2 Type of change

- Reduction in lead length scrap material for tape and reel packaging
- Change in reeling direction according to EIA-468

Product Change Notification					PCN-Changes to Tape and Reel Packaging		
owner	creation date	release date	released by	change order no	rev	page	D10-032-807
schmidre	19.12.2018	19.12.2018	haeckima	2016867	A	1 of 2

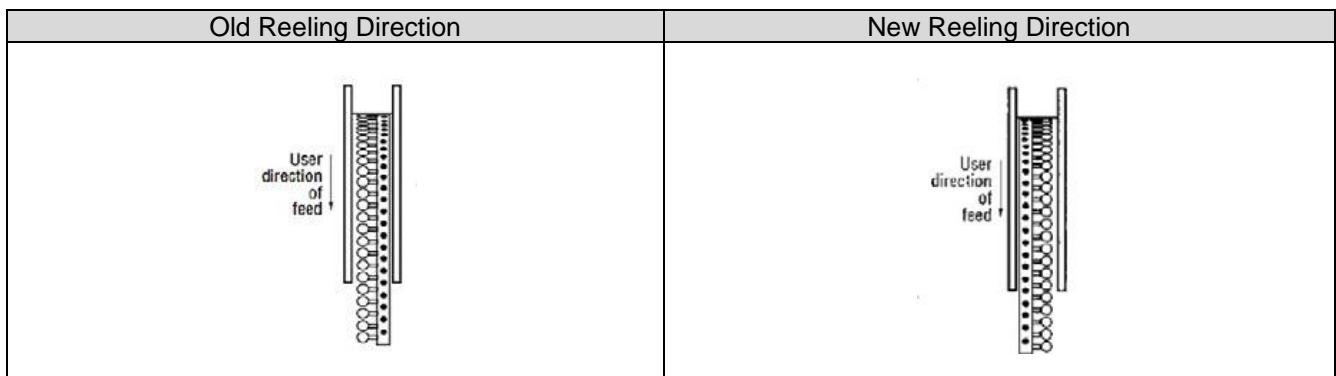
The total length of the leads will be shortened as shown in the example pictures below. The actual dimension changes will vary between models. Assuming the components are removed from the tape and reel packaging by cutting the leads at the tape edge, the form, fit and function of the components are not affected. There is no change in the mechanical, electrical or material properties, and the components' performance and agency recognition remains the same.

In the same step we take the chance to improve our conformity with EIA-468 by changing the reeling direction. If there are major production obstacles occurring due to this change, please get in contact with your local SCHURTER sales representative.
